BLOCK 20A, EDMONDSON PARK

Affordable Housing Project

STATE SIGNIFICANT DEVELOPMENT APPLICATION

REVISION ID	AMENDMENT	DATE
D	ISSUE FOR COORDINATION	13/11/2025
P1	ISSUE FOR COORDINATION	18/12/2025
A	ISSUE FOR SSDA	22/01/2026
B	RESPONSE TO RFI	29/07/2026

BASEMENT 01 PLAN

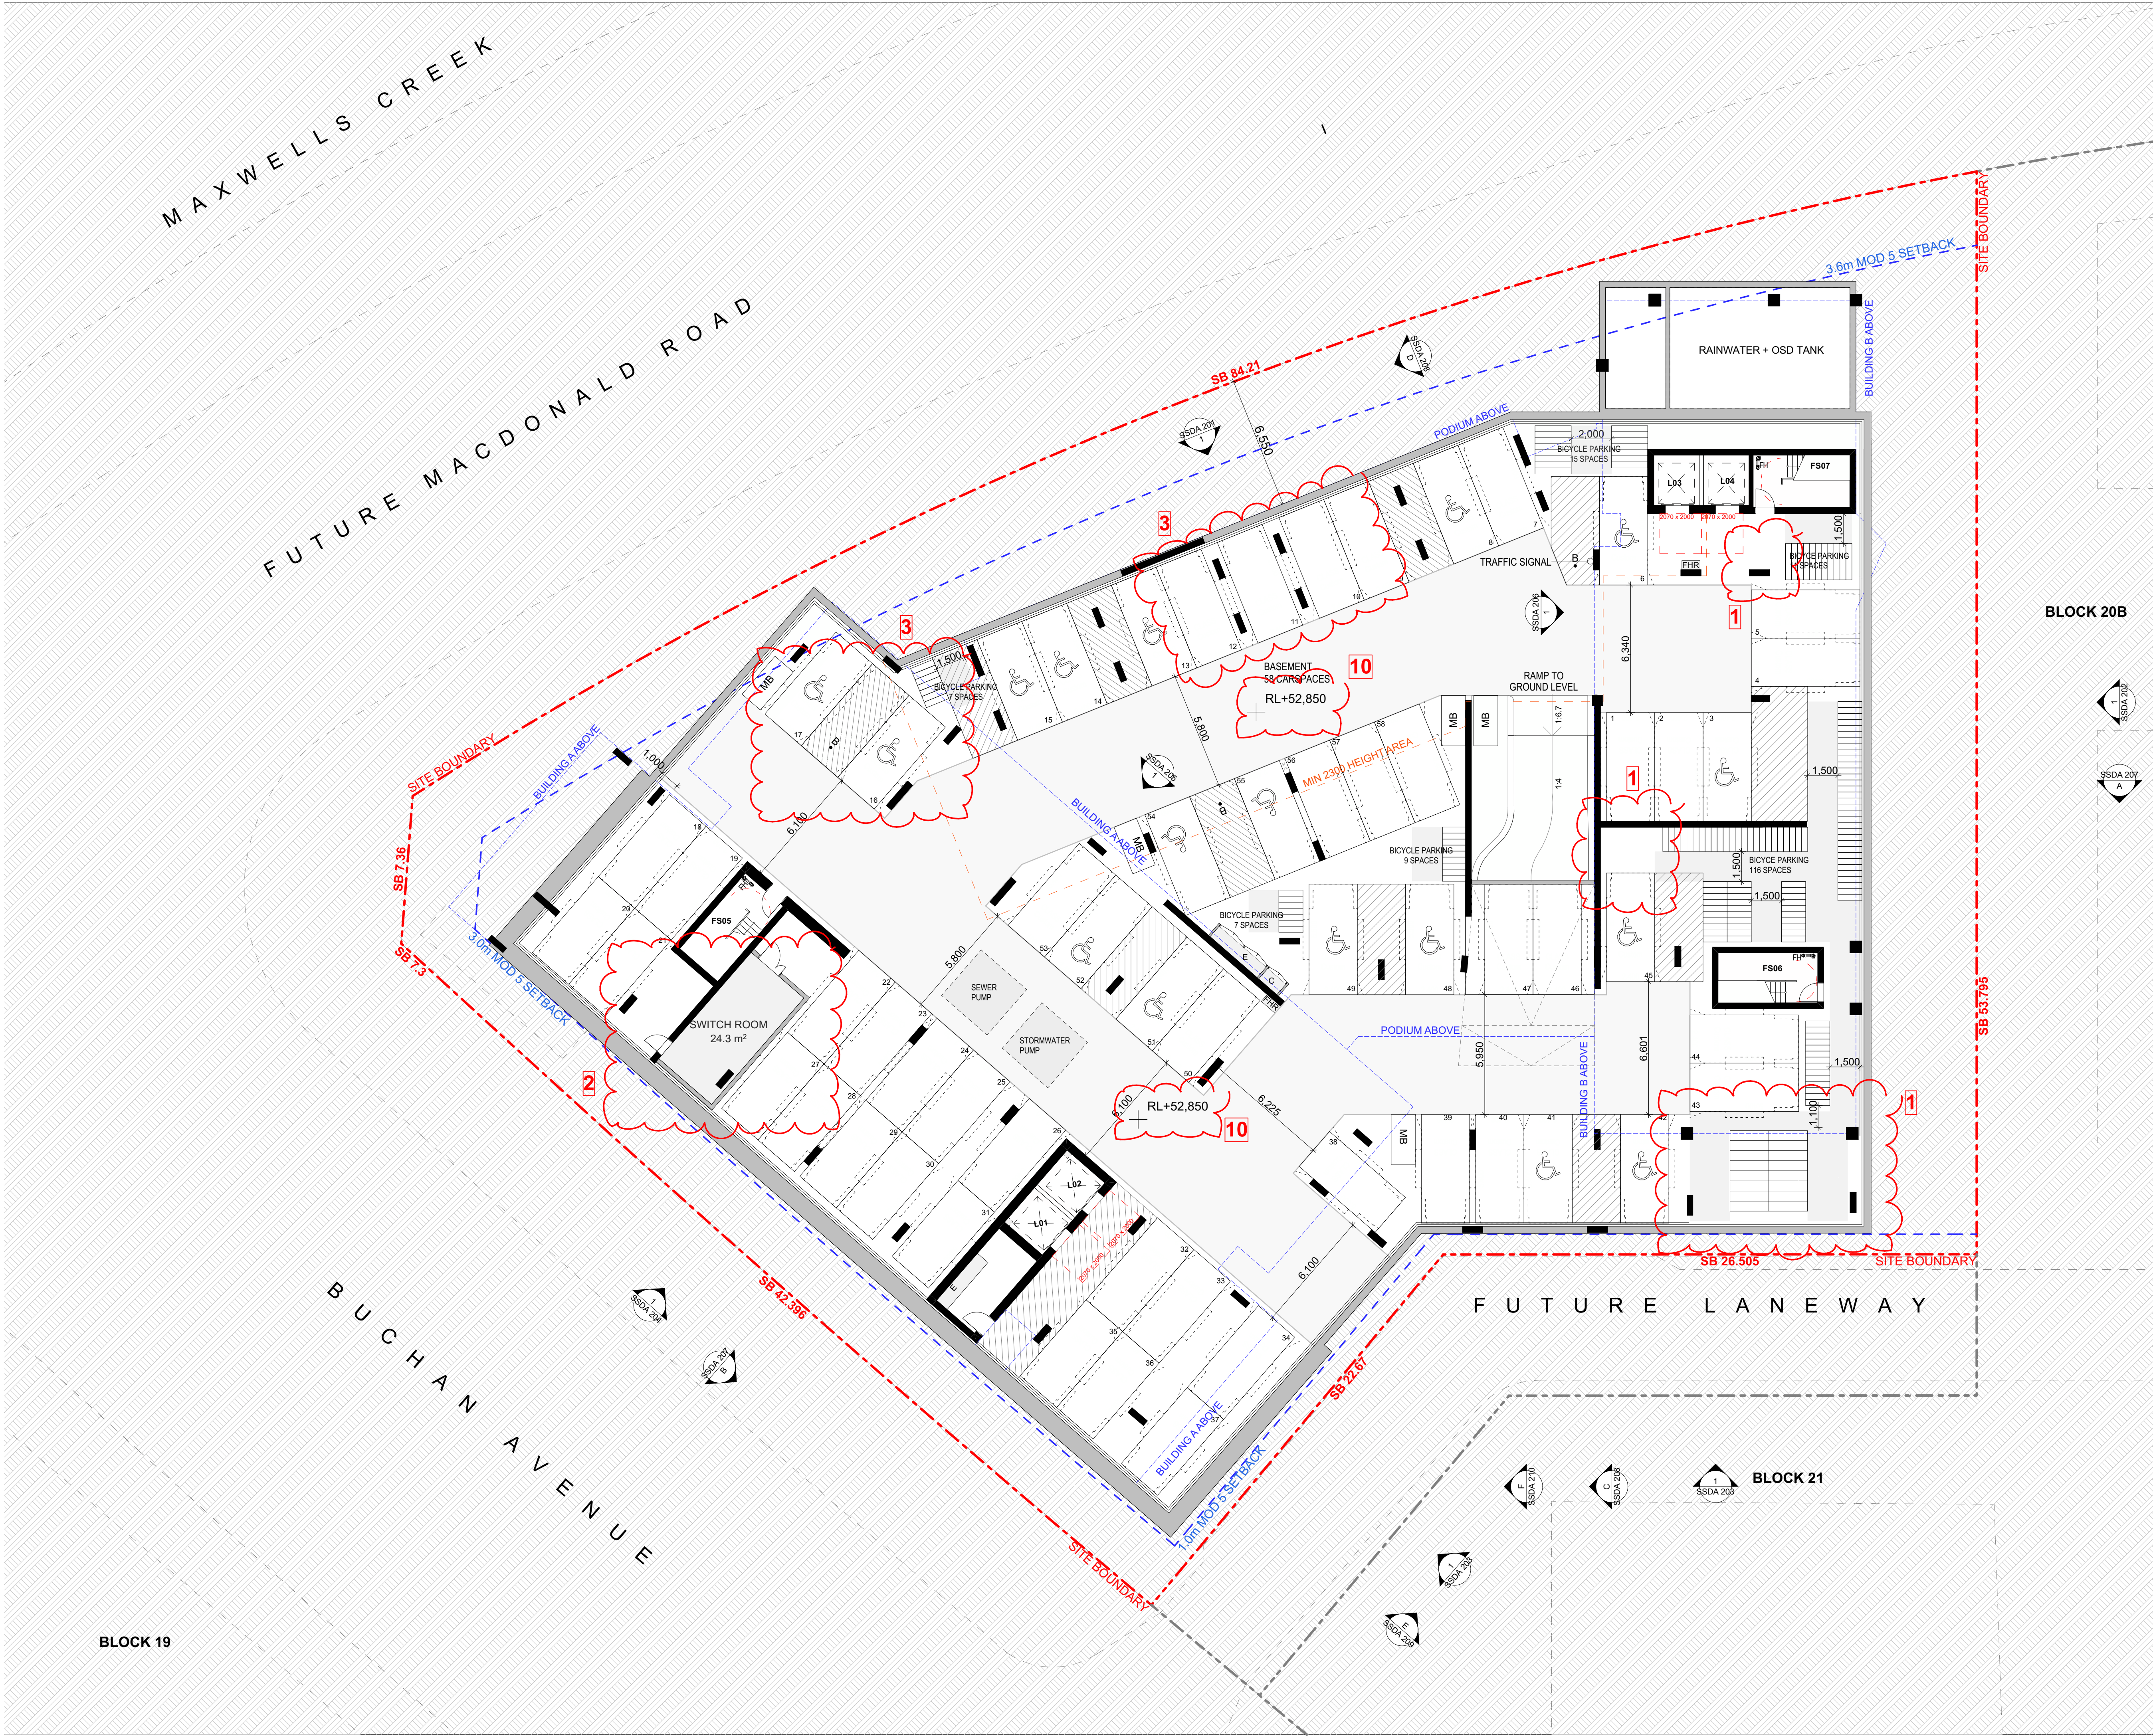
1. BIKE PARKING RELOCATED

2. SWITCHROOM RELOCATED

3. ACCESSIBLE PARKING RELOCATED

4. GARBAGE ROOM ADJUSTED FOR BETTER CIRCULATION

5. RESIDENTIAL WASTE ROOM RELOCATED

6. CARPARK ENTRY RAMP INCREASED IN LENGTH

7. RAMP ADDED TO ENTRY

9. BASEMENT RL AMENDED

LEVEL 01 PLAN

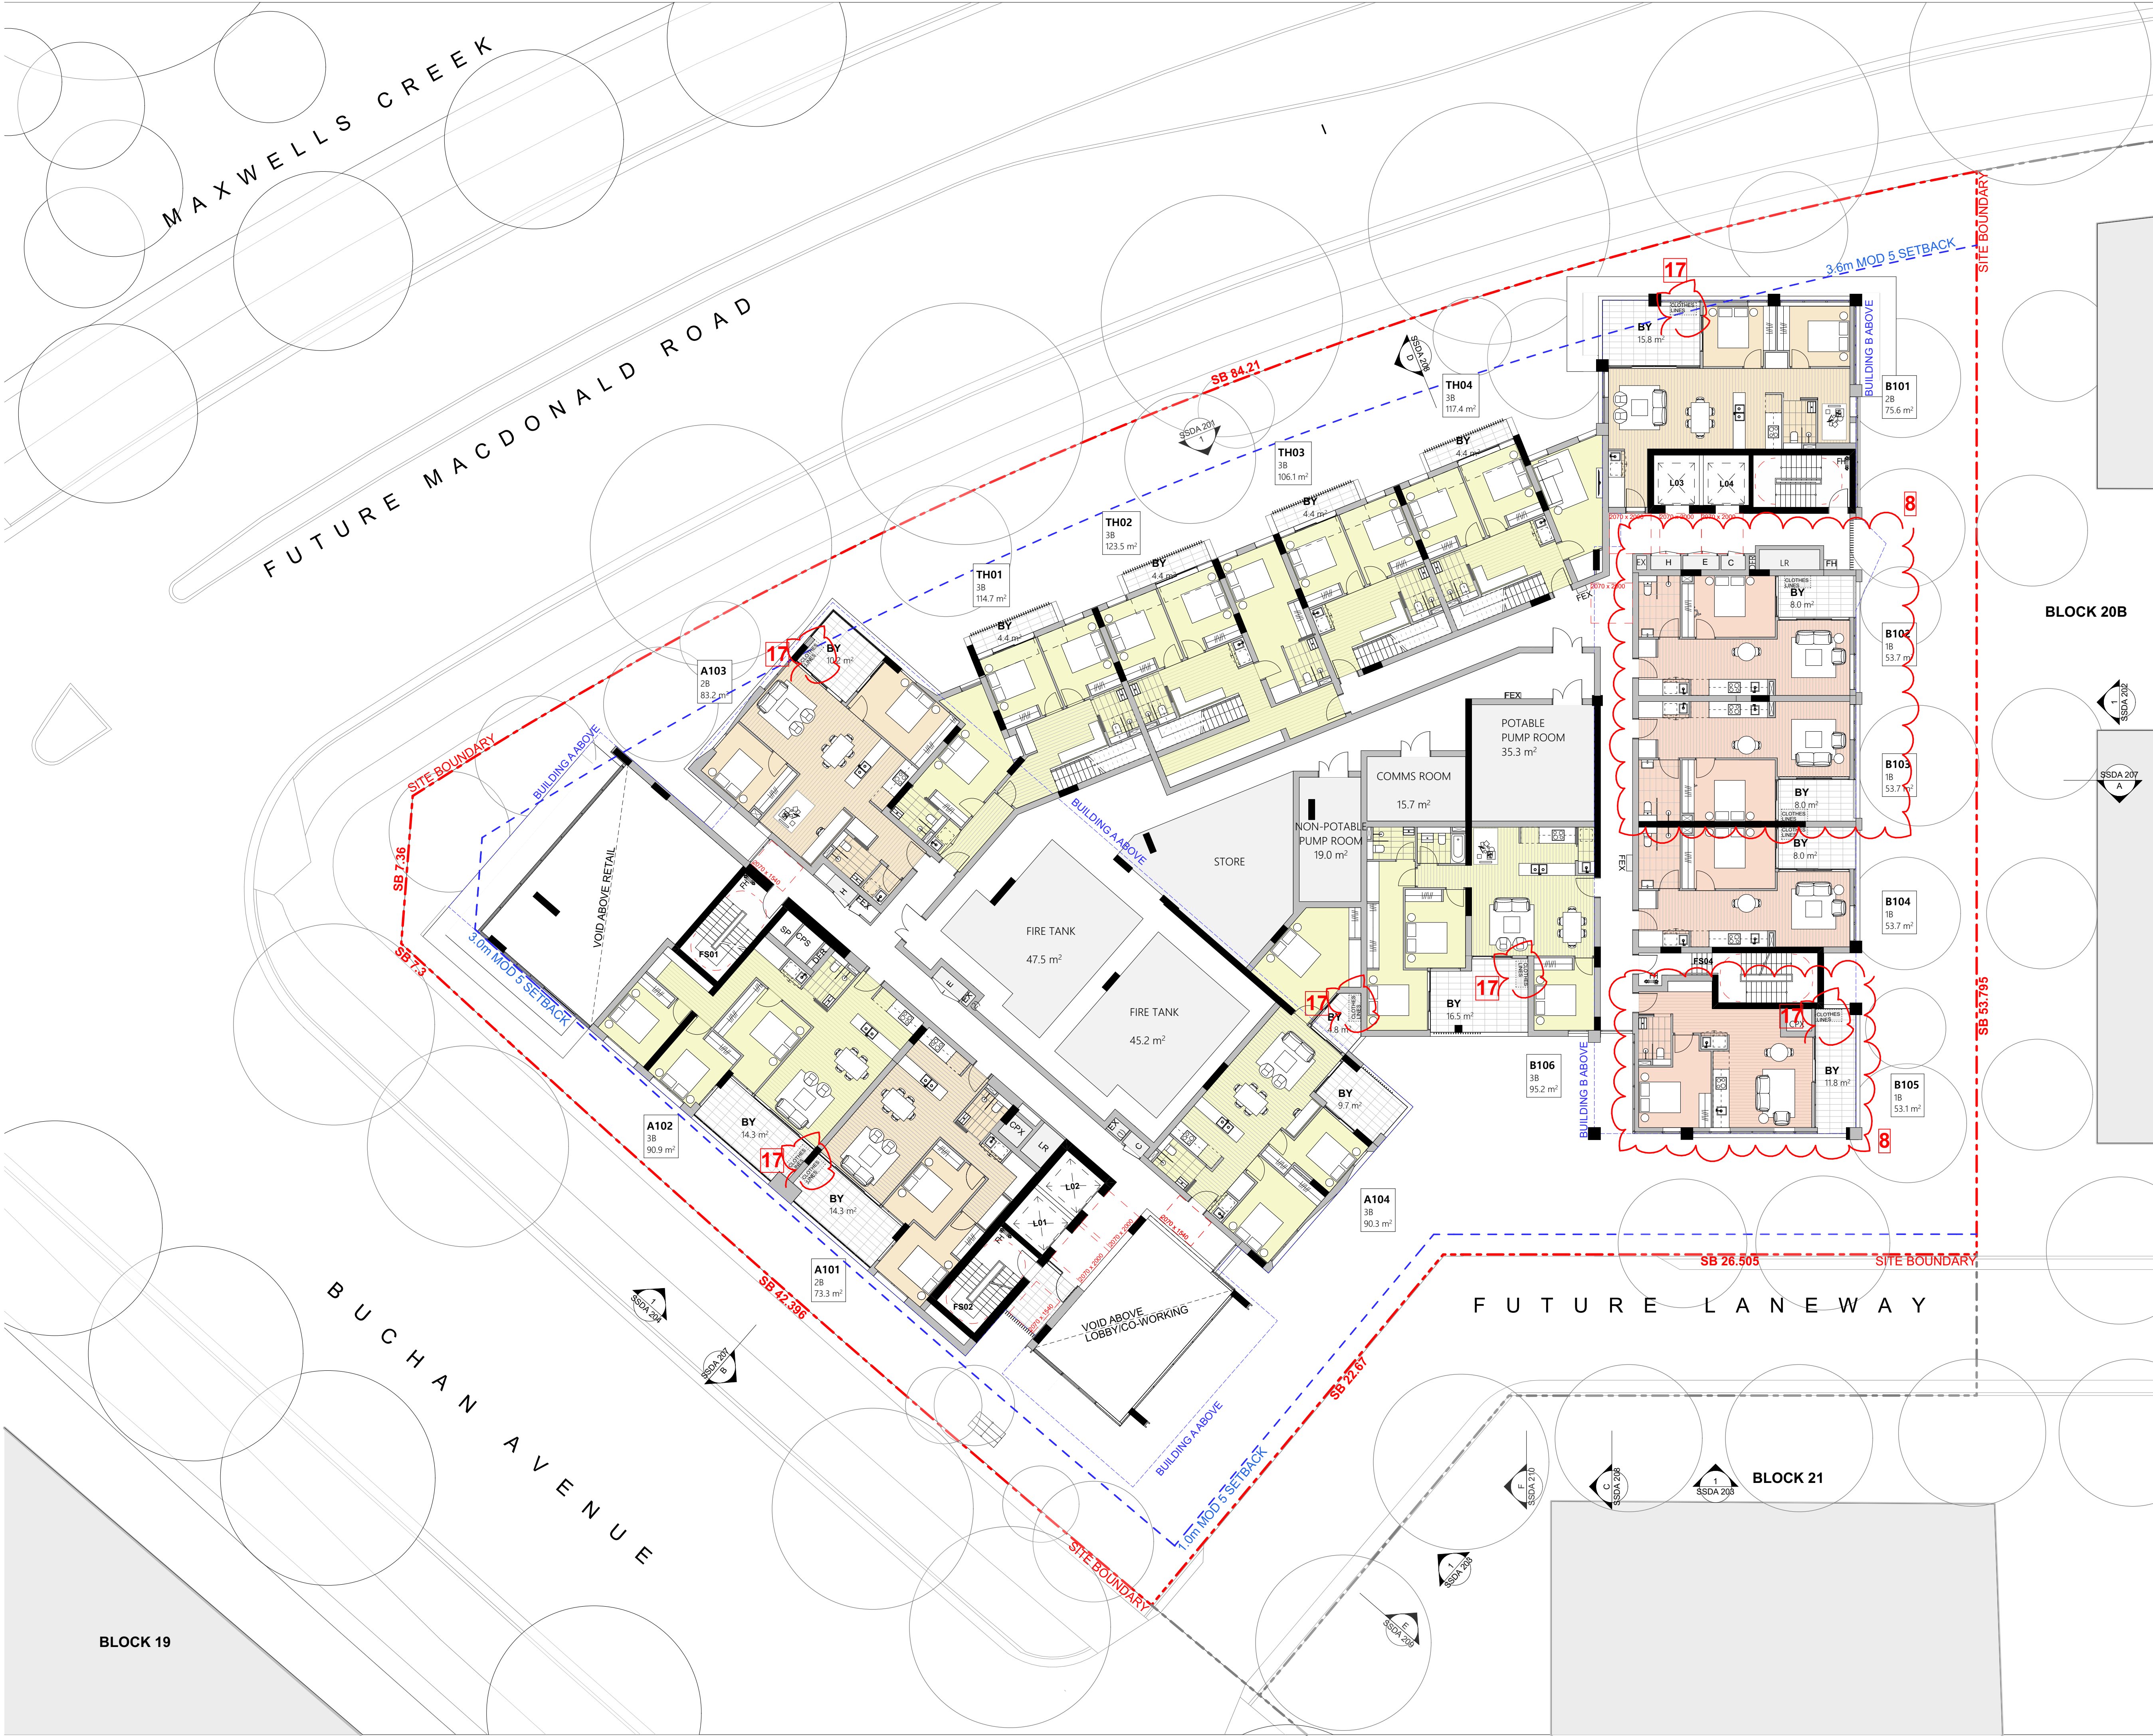
8. APARTMENT LAYOUTS FLIPPED / ADJUSTED FOR GREATER AMENITY

11. RL AMENDED

14. FACADE AMENDED DUE TO APARTMENT FLIP

DRAWING TITLE
NORTH ELEVATION

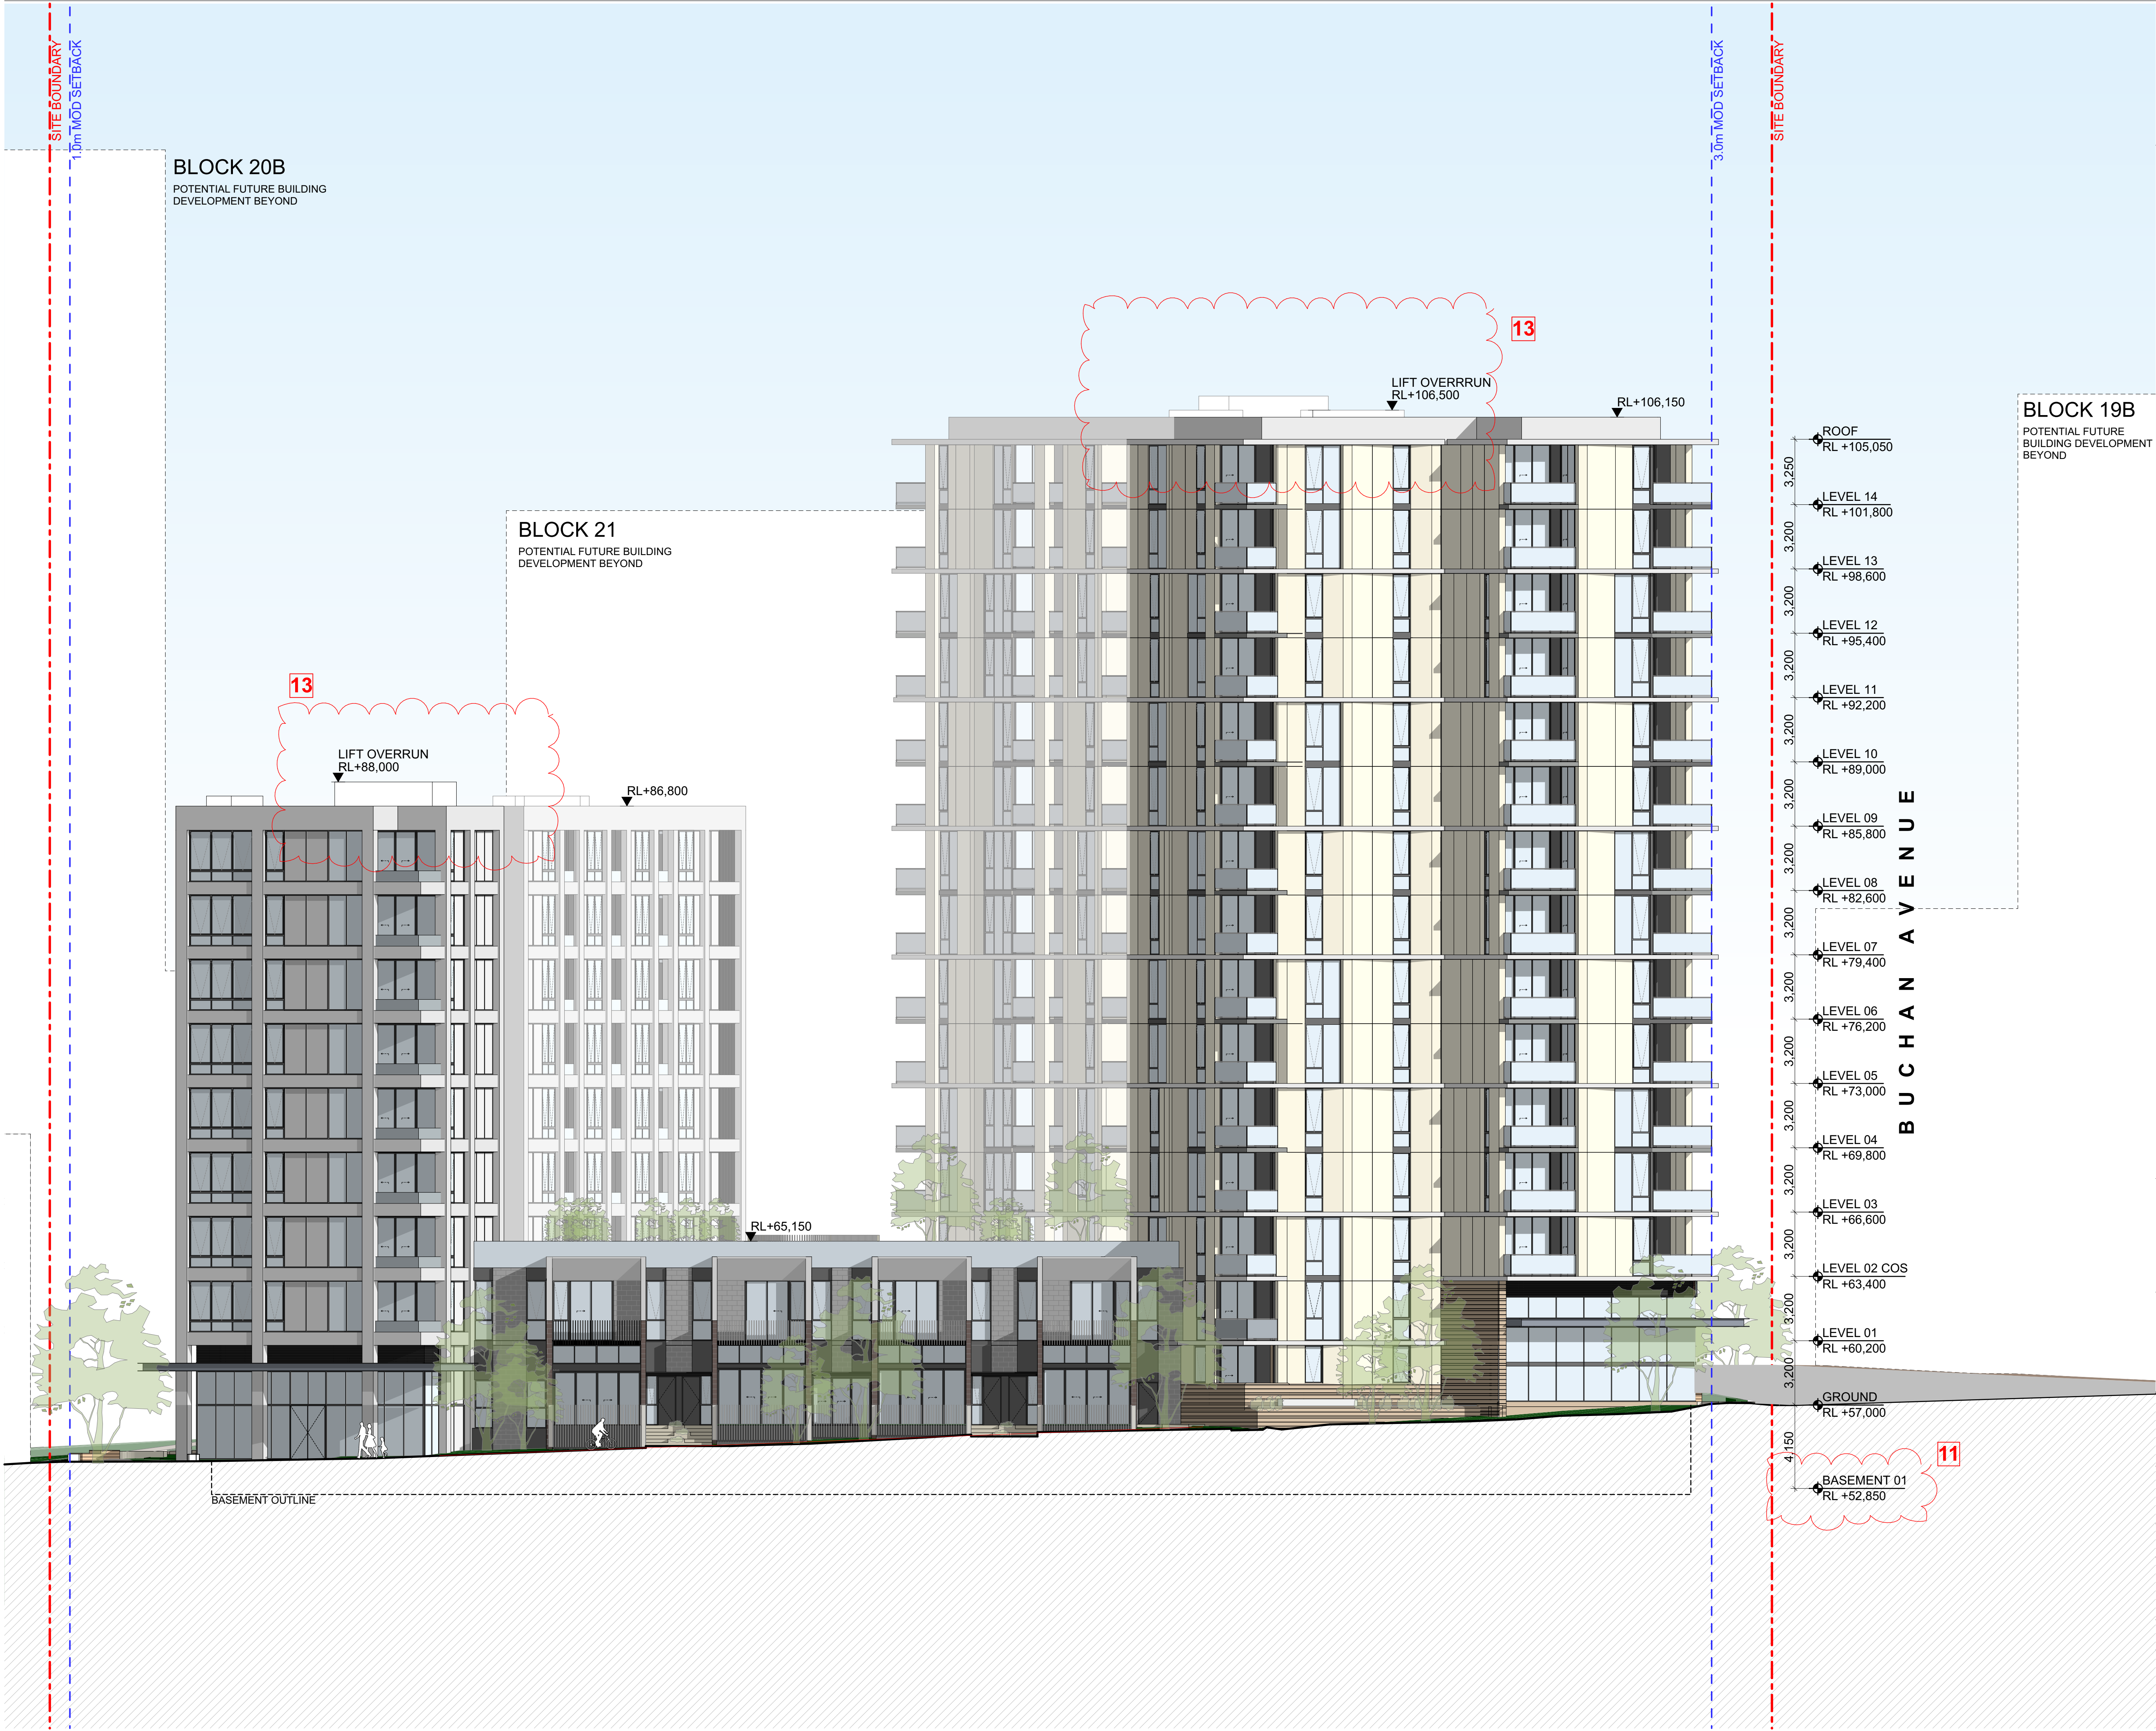
1. BIKE PARKING RELOCATED
2. SWITCHROOM RELOCATED
3. ACCESSIBLE PARKING RELOCATED
4. GARBAGE ROOM ADJUSTED FOR BETTER CIRCULATION
5. RESIDENTIAL WASTE ROOM RELOCATED
6. CARPARK ENTRY RAMP INCREASED IN LENGTH
7. RAMP ADDED TO ENTRY
8. APARTMENT LAYOUTS FLIPPED / ADJUSTED FOR GREATER AMENITY
9. BASEMENT RL AMENDED
10. FIRE CONTROL ROOM REMOVED
11. RL AMENDED
12. SP REMOVED AND APARTMENT ADJUSTED FOR GREATER AMENITY
13. PLANT ROOM REMOVED
14. FACADE AMENDED DUE TO APARTMENT FLIP
15. GFA AMENDED
16. MATERIAL DESCRIPTION AMENDED
17. CLOTHESLINES ADDED
